# Appendices

REDFERN STATION REDEVELOPMENT PROJECT  
Peer Review of Previous Options C, D + E  
REVISION 1 – 3 March 2009

Redfern Station Redevelopment Project – COX Peer Review of Previous Options C, D + E

Figure 1: 2008 3.5hr Peak AM Demand and destination percentages

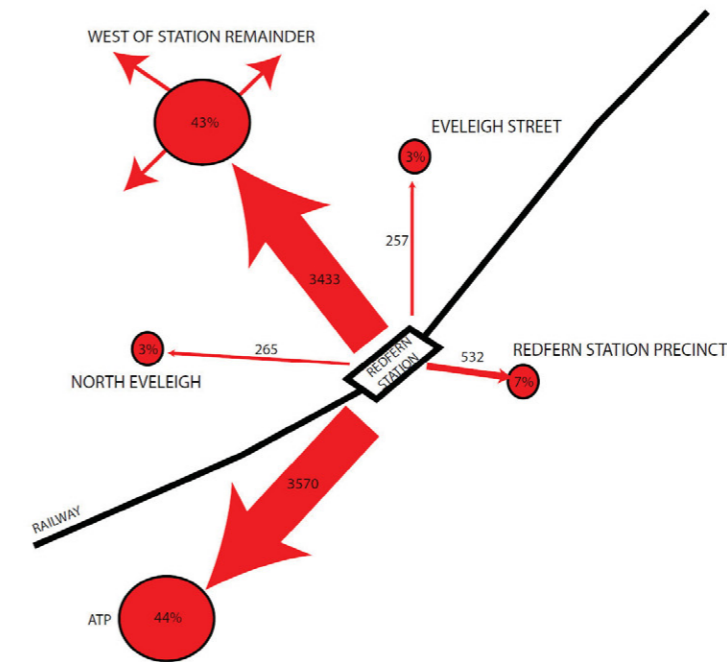
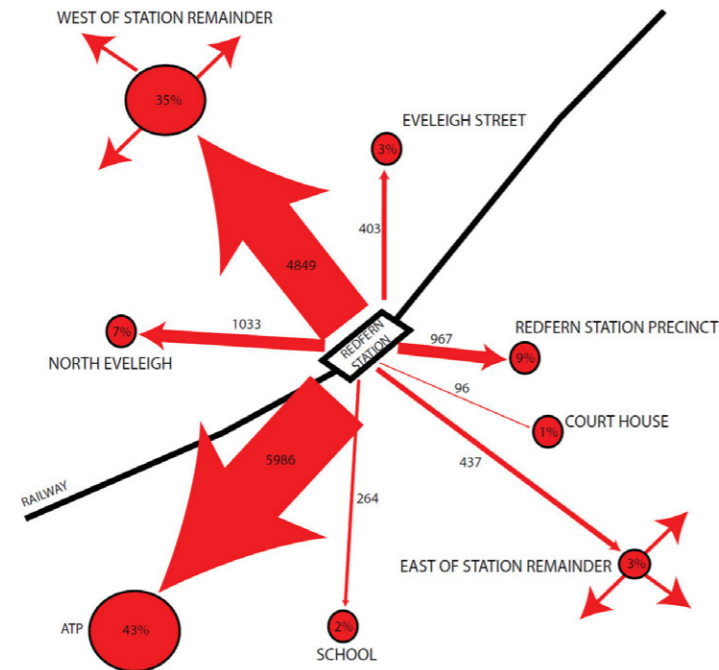
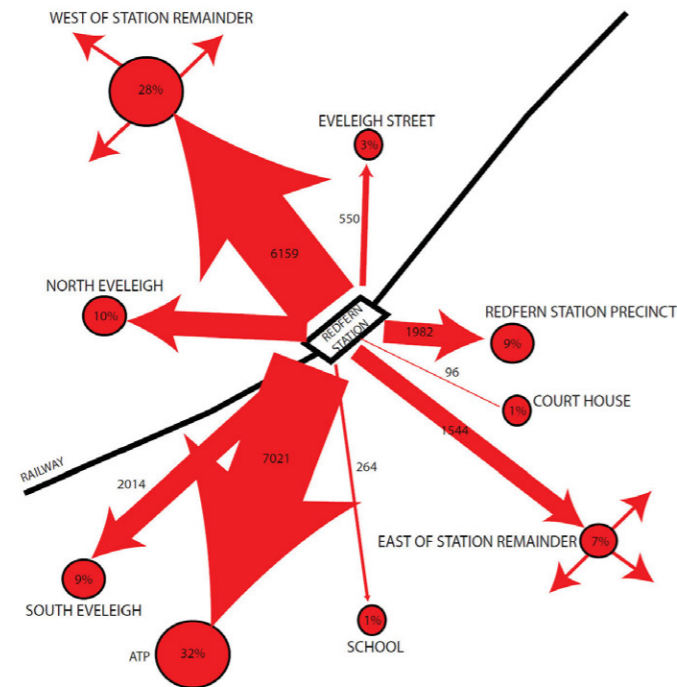
The Connell Wagner report has focused on the suitability and performance of the vertical transportation elements of the station, and thus their approach to predominantly focus on paid movements is reasonable. However, the only reference to external station movements is provided in section 5.3 of their report and it is unclear a) how the percentages of east/west movements have been generated and b) what the likely shift of movements would be between now and 2031 and on to 2061. An understanding of external movements is important to understanding the likely shift in peoples' movements if changes in station entry/exit positions occur (i.e. as is the case in Option C). Thus understanding the percentages travelling to ATP, the University, North Everleigh etc. is very important to the analysis of the paid concourses and gatelines. This appears to be overlooked in the Connell Wagner report.

**Recommendation:** Arup have reviewed the 2008 gateline data to test the current east/west splits against current landuse estimates provided by RWA for 8 key locations around the station. Arup have then used the future landuse estimates to predict the changes in movements at 2031 and 2061. The following charts indicate the percentages now and in the future. Arup recommends that these estimates are reviewed and agreed by RailCorp and/or RWA before further design analysis is undertaken.

Figure 4: Maximum Queue (per stair) for Option C, D and E at 2061

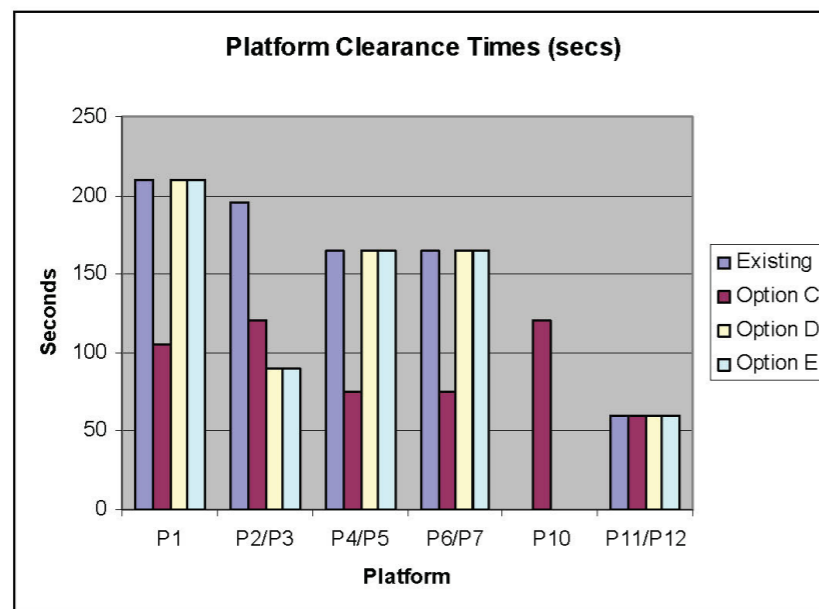
The graph below shows the comparison of estimated platform clearance times at 2061. The chart demonstrates that key platforms are estimated to have a clearance times in excess of 90 seconds and that for Options D, E and existing, the clearances are above that of the headway of the train frequency on P2/P3, P4/P5 and P6/P7.

Option C has a high clearance time for P10 due to the nature of the access route to P11/P12. Option D/E performs better on P2/P3 given that more vertical transport is provided – however, there are concerns that the improvement of P2 will be offset by a worsening of other platforms based on this design. This is explored in later sections.

Figure 5: Maximum Queue (per stair) comparison for Option C at 2031

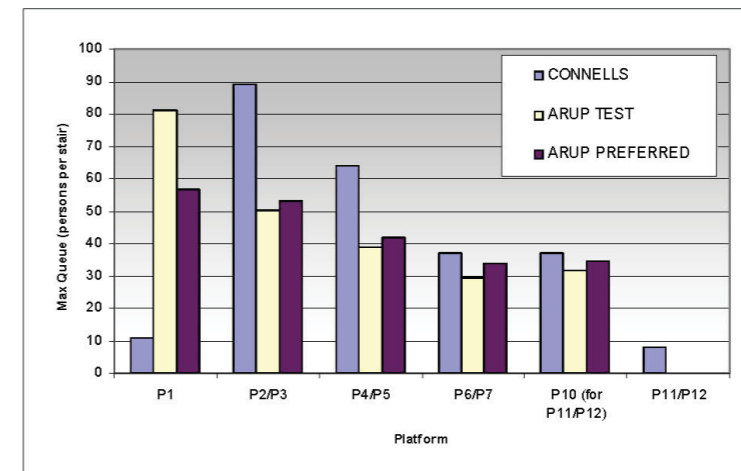
The results show that we have not been able to replicate the Connell Wagner analysis and without detailed discussion with Connell Wagner it is difficult to fully understand the differences. However, the significant differences that require further investigation are for Platform 1 and Platform 2/3. For P1, Connell Wagner is indicating a maximum queue of only 11 people from an alighting load of 340 people at 2031. Given a 5m stair which Connell Wagner has assumed a capacity of 185 per minute (5 \* 37ppm), then we would expect at least 340-185 = 155 to still be queuing on the platform at the end of 1 minute, or 78 per stair.

For P2/P3, Connell's are predicting a maximum queue of 89 people, with a maximum duration of 90 seconds, whereas Arup are predicting a maximum queue of 50 per stair and with a clearance of 75 seconds. The difference may relate to whether Connell Wagner is reporting a maximum platform queue, rather than a stair queue. Further investigation is required.

**Recommendation:** Arup disagrees with the analysis for P1 by Connell Wagner and recommends using the Arup results as presented within fig 5 and 6. A computer simulation model of the P1 scenario has been constructed and is shown below.

Figure 8: Estimated platform clearance times for Option C at 2031 and 2061

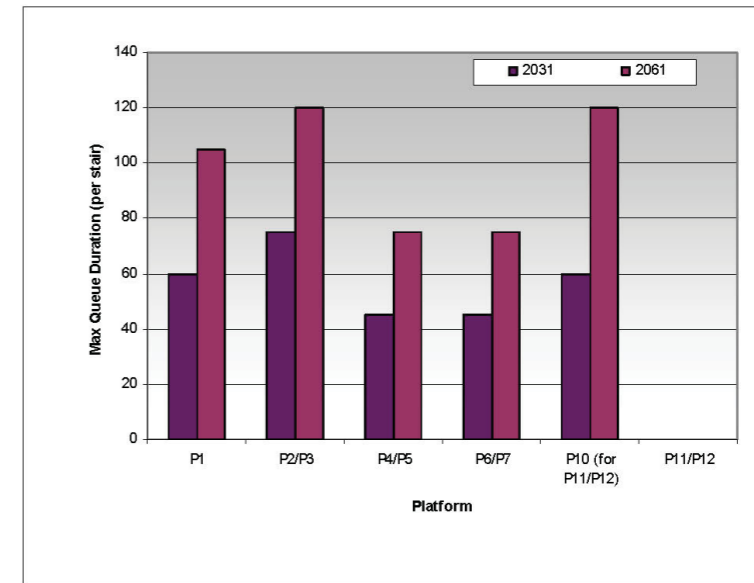
The platform clearances for P1, P2/P3 and P10 (for travel to P11/P12) are all above the 90 seconds maximum criteria and additional vertical transport is required. Given platform width is constrained the design team will need to investigate:

The table below indicates the VT provision required to meet a 90 seconds clearance time. Given platform space is limited – especially for P2/P3, there is limited opportunity to increase VT to 4.4m. Arup recommend examining both interchange and entry/exit movements in more detail in order to test what benefits can arise if we maintain the existing stairs at the northern end to manage interchange flows.

Fig.1 Protection zone overlayed on Option C

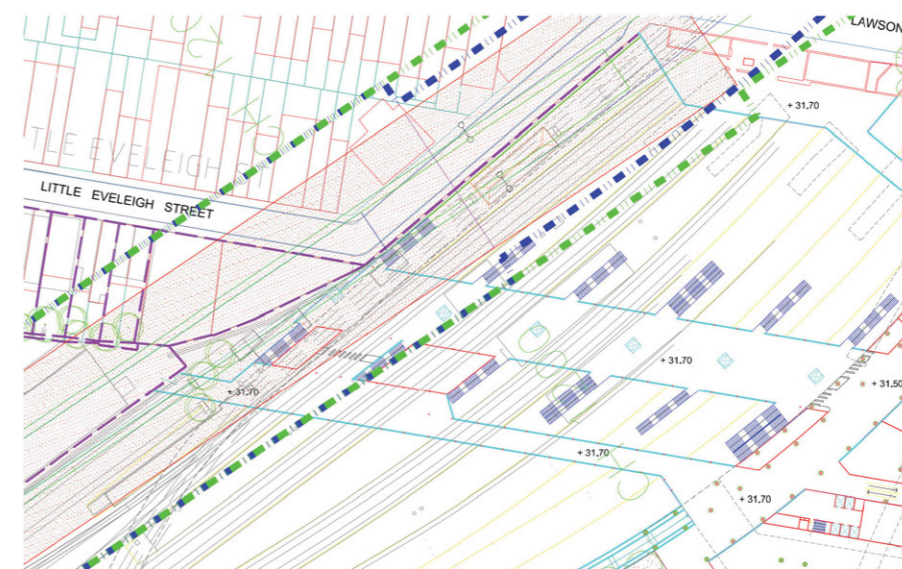
The status of the metro west protection zone needs to be closely monitored during the life of the project due to the development of other rail projects in Sydney. These projects may impact on the proposed use of the protection zone currently in place.
